March 24, 2026

Re: Santa Maria Community Services
Project No. 25109
Addendum No. 5

Sheet Title: SITE LAYOUT PLAN

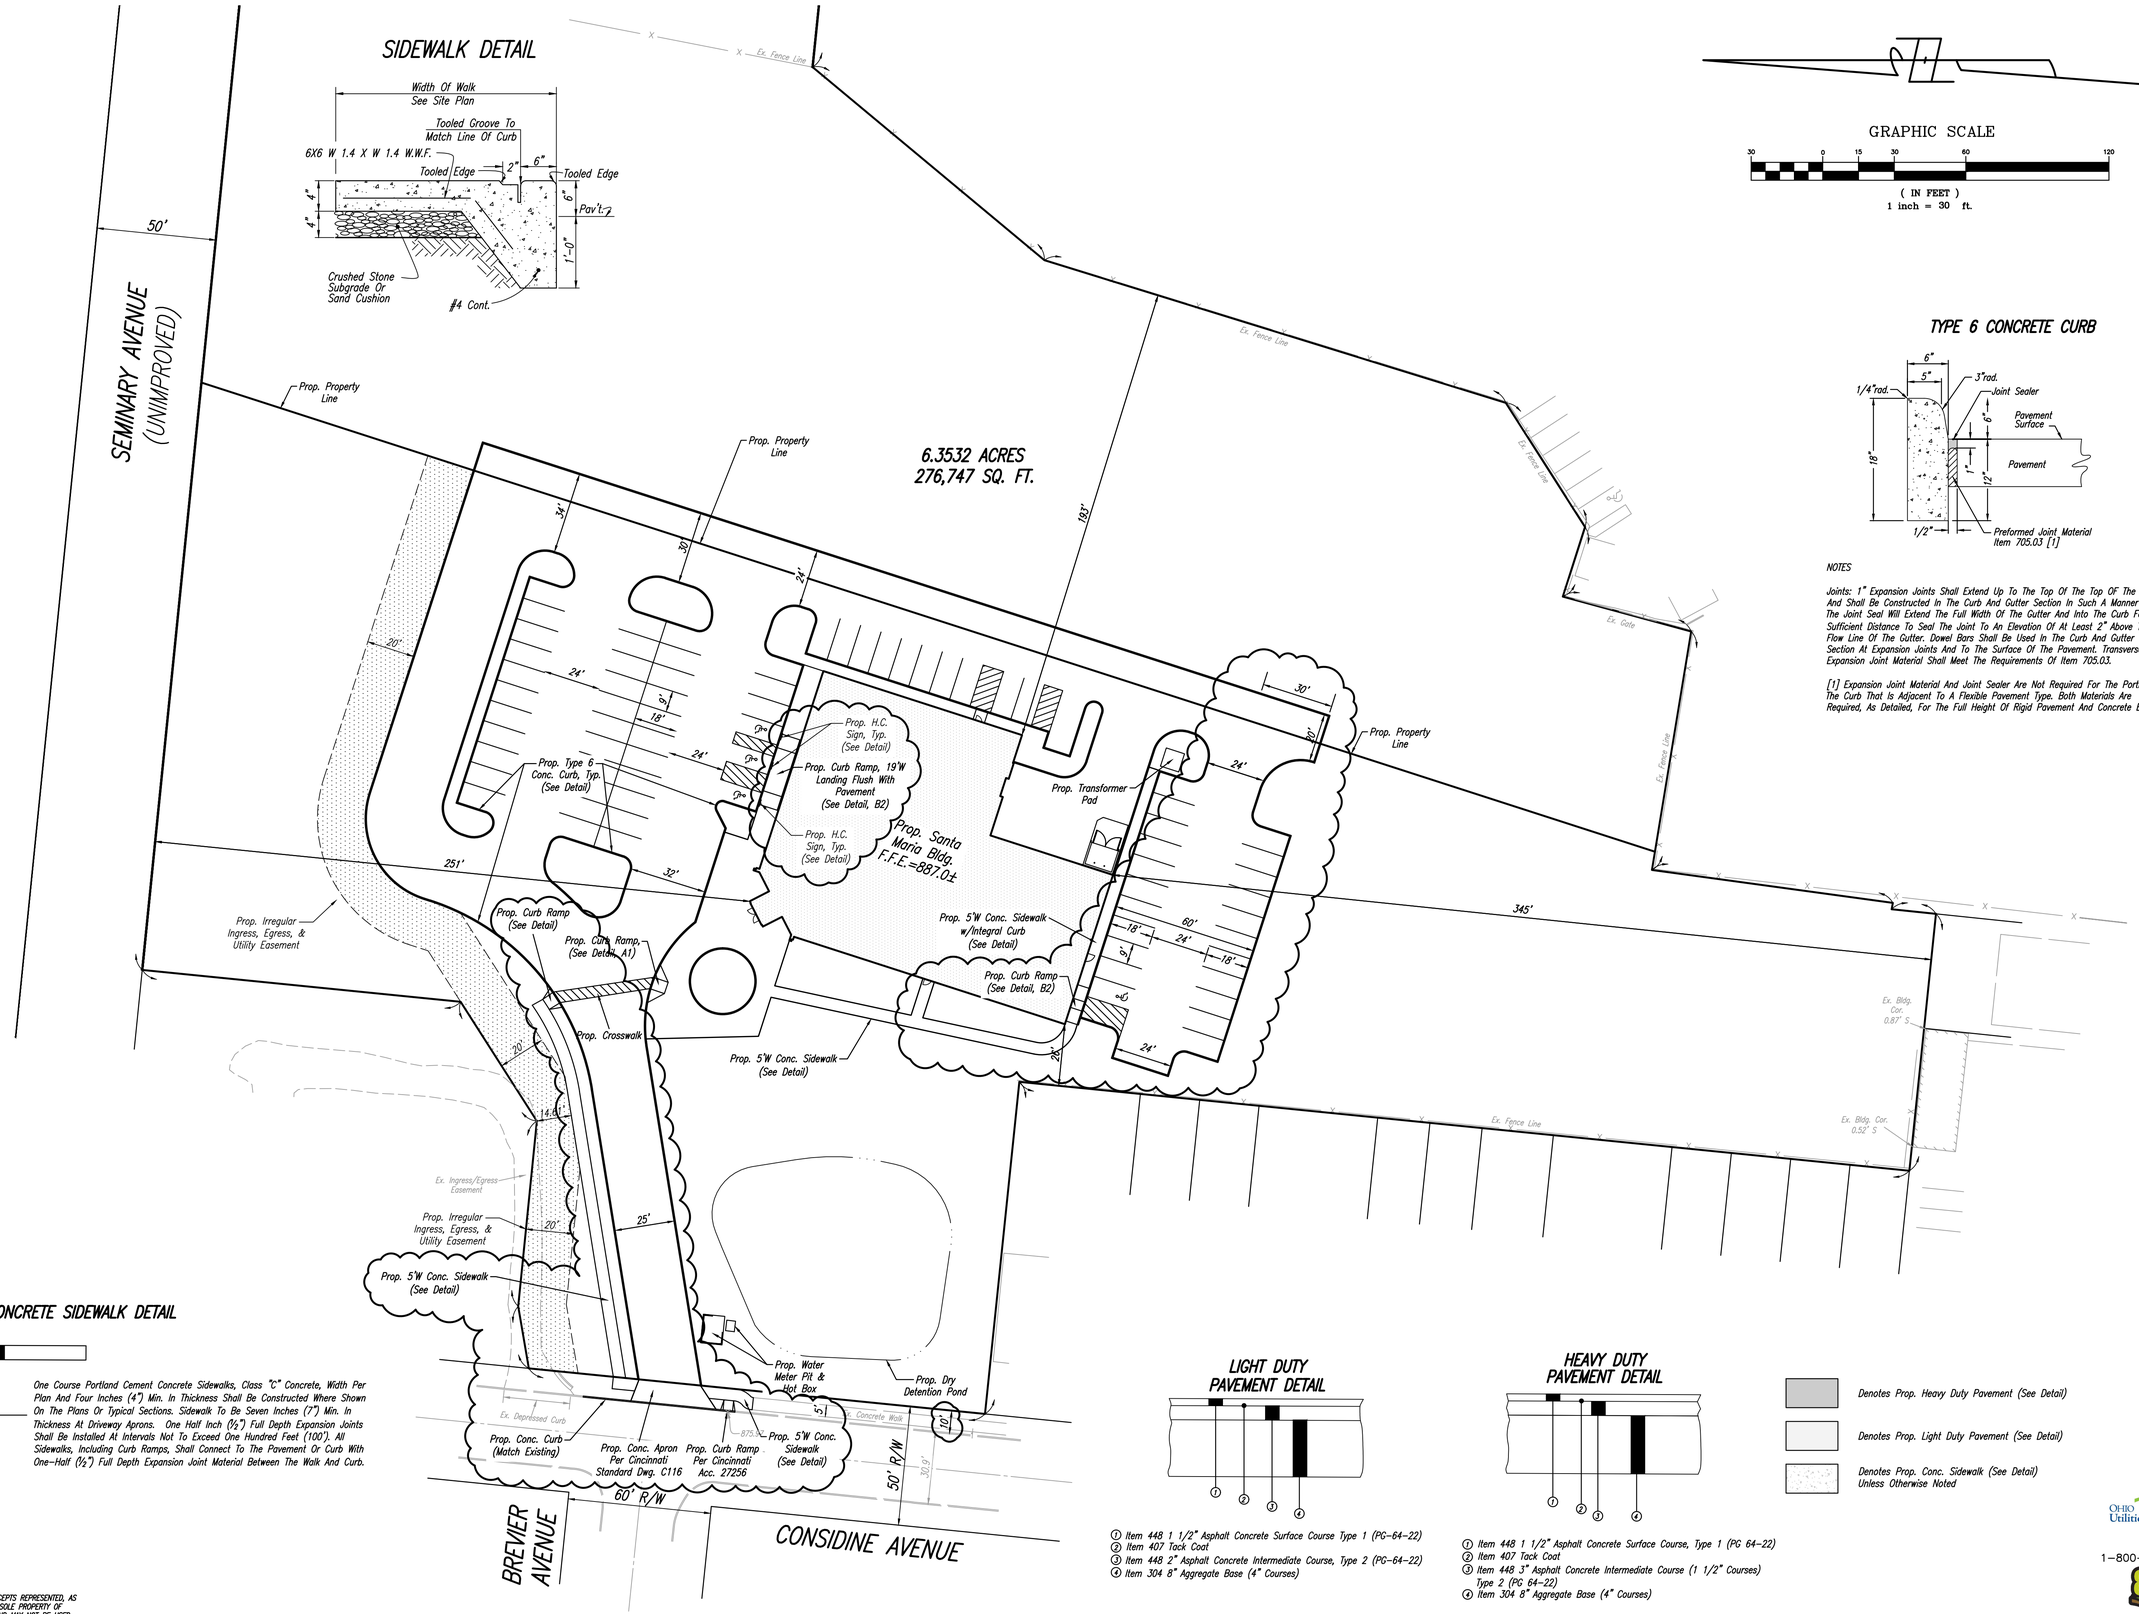
C500 Driveway reduced to 25' wide.

DOTE: Dimensions added to ex. Considine R/W and sidewalk.

Curb ramp added on Considine.

Considine sidewalk design refined.

Hammerhead turnaround added to southeast corner for fire truck turnaround per meeting with Captain Rob Hart.

Sidewalk added for new egress door on west side of building.

1 G003 **FIRST FLOOR PLAN - LIFE SAFETY**
1/16" = 1'-0"

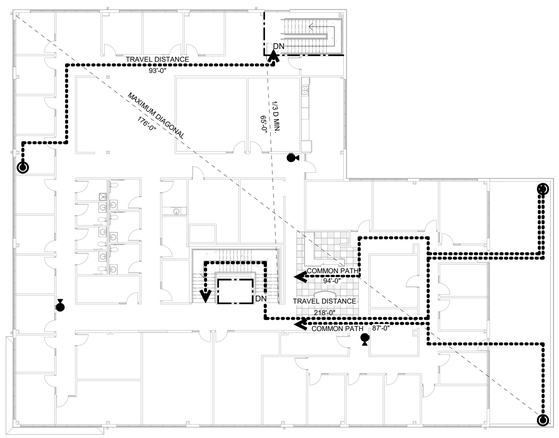
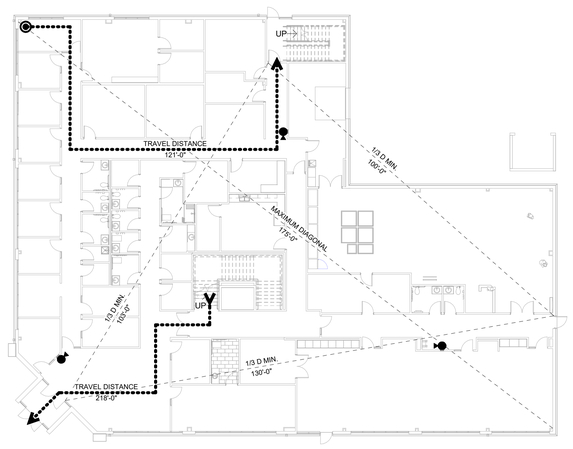
G003 Updated Code information from Permit Review response.

1 A001 ARCHITECTURAL SITE PLAN
1/8" = 1'-0"

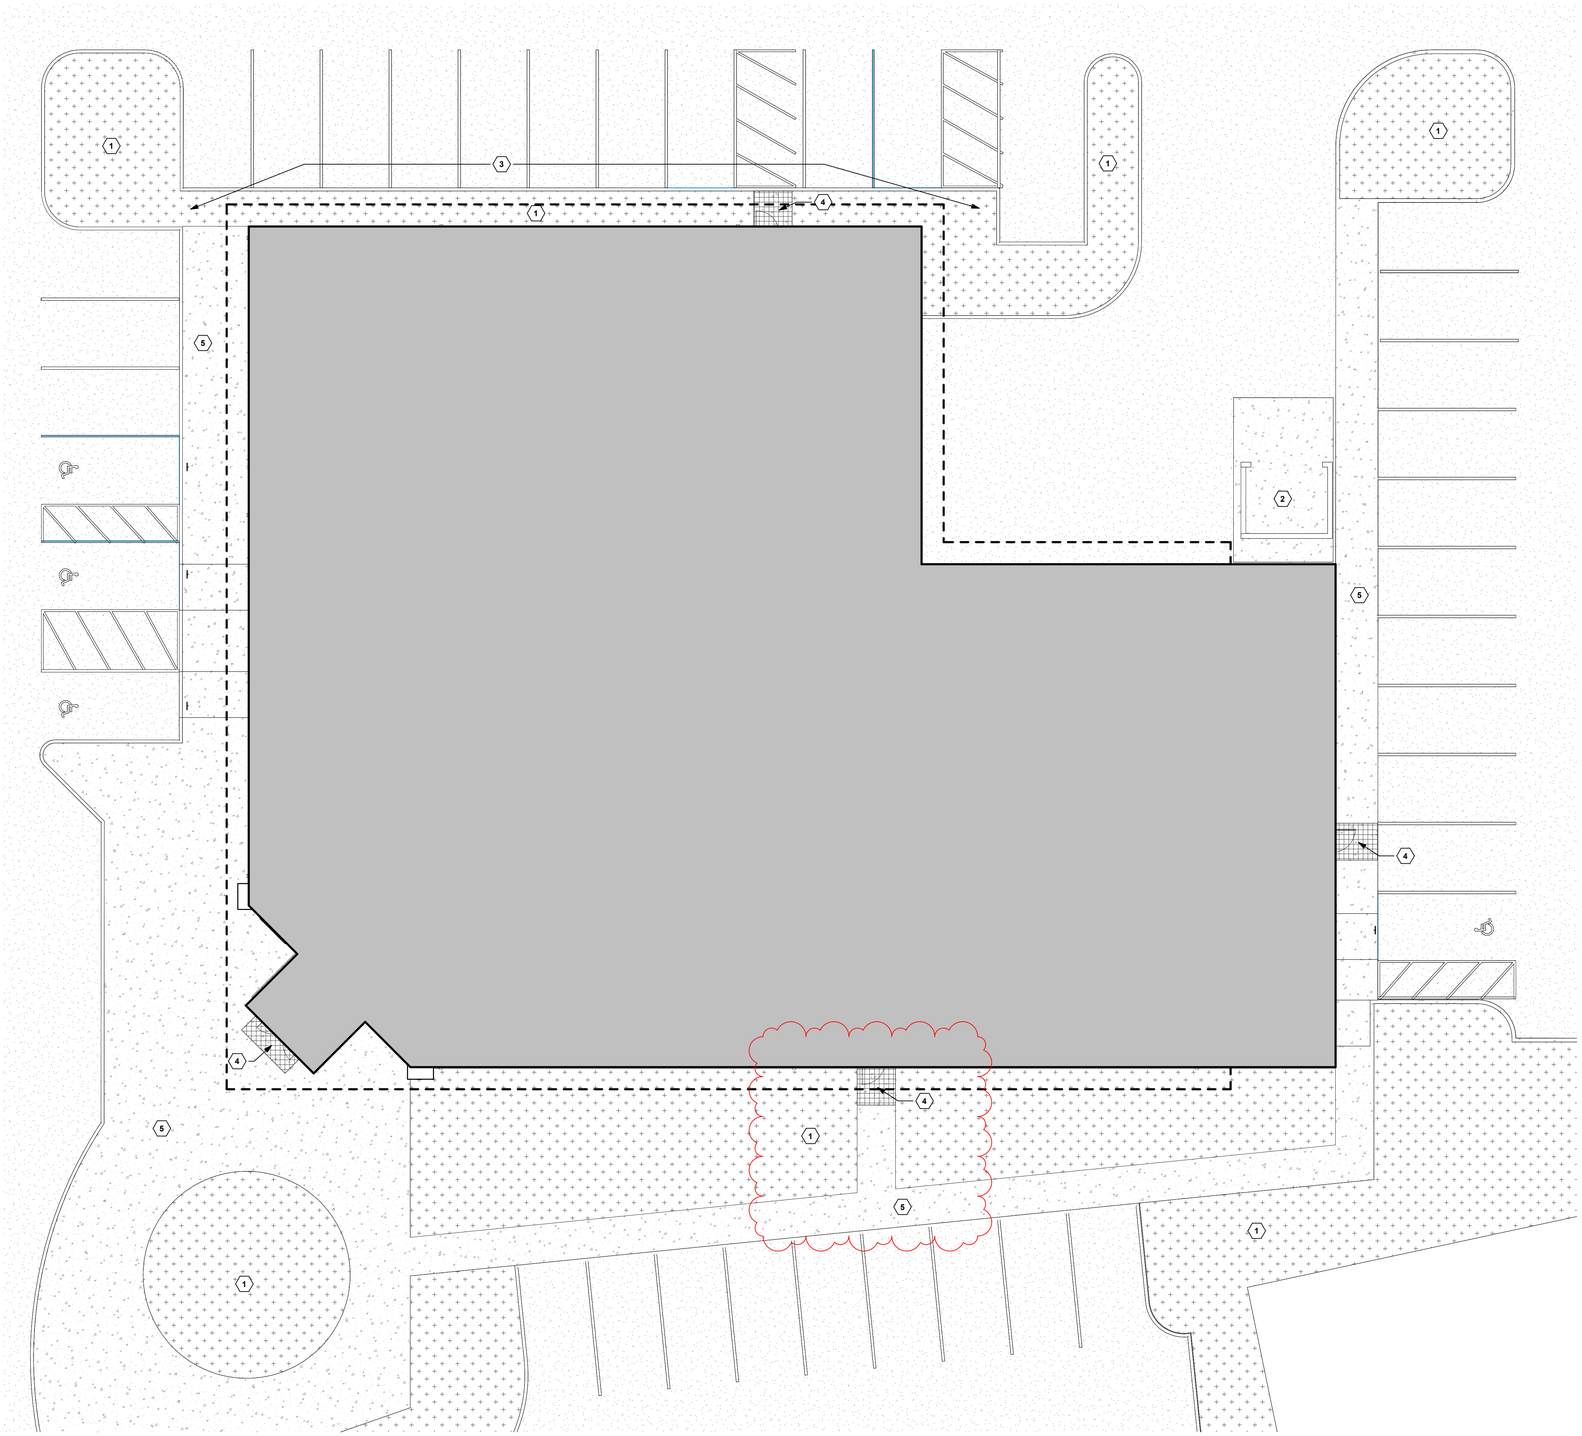
A001 Added new exterior exit door (set into storefront window system), frost slab and sidewalk connection.

1 FIRST FLOOR PLAN
A101 3/16" = 1'-0"

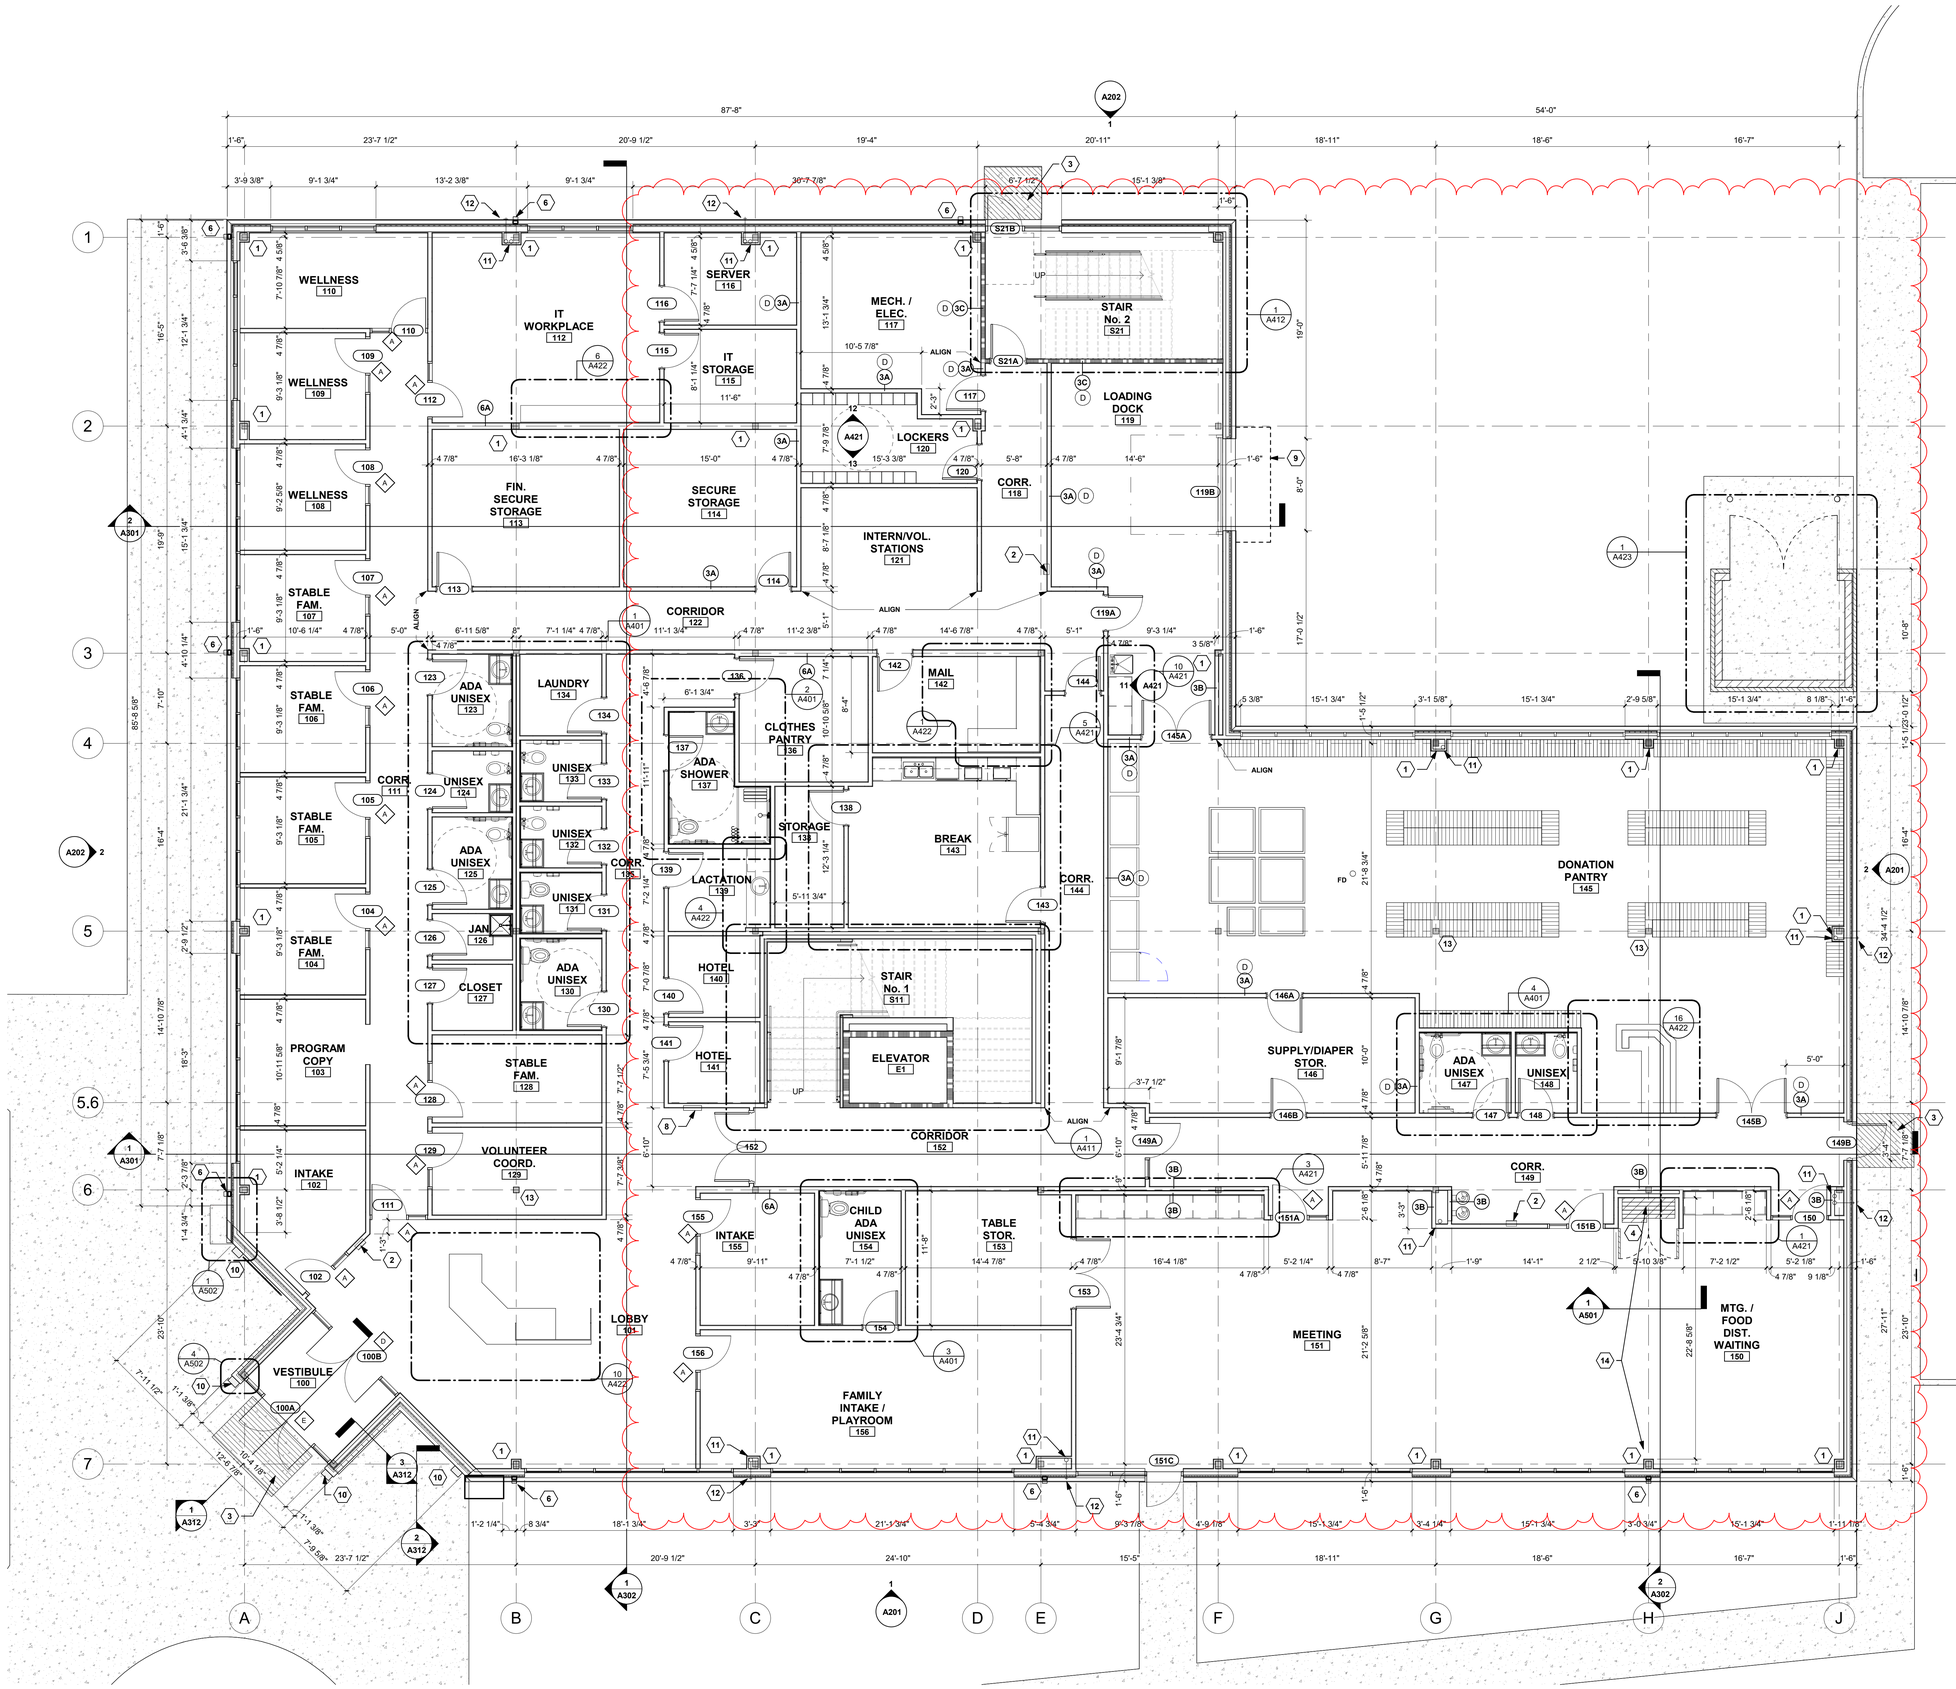
A101 Extensive revision to the architectural plan, with repositioned rooms and doors. A new exit door has also been added to Meeting #151.
